ATTACHMENT 4A

Emergency Plan Marked-up Pages – Dresden Station

Exelon Standardized Emergency Plan EP-AA-1000
and
Emergency Plan Annex EP-AA-1004

Figure F-3: NRC Communications for Nuclear Response

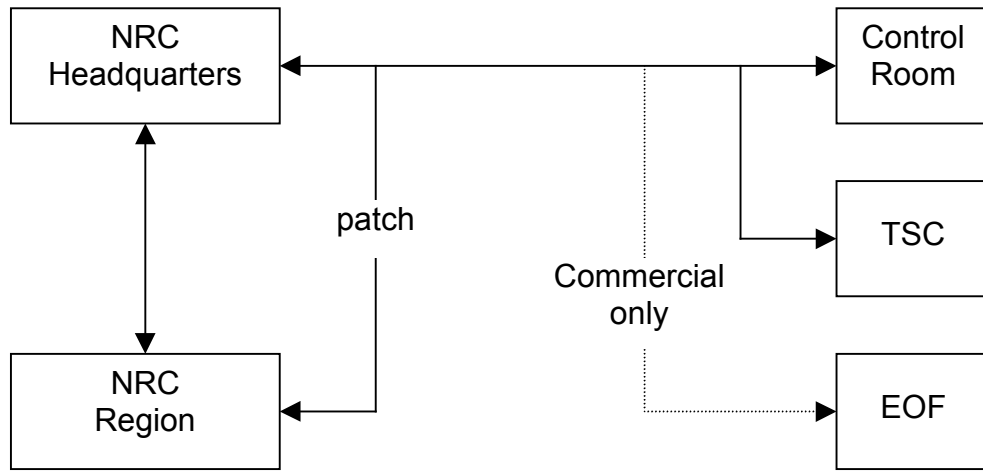
~~Health Physics Network (HPN): There also exists a separate dedicated telephone between the NRC, the TSC, and EOF for conveying health physics information to the NRC as requested or as an open line.~~
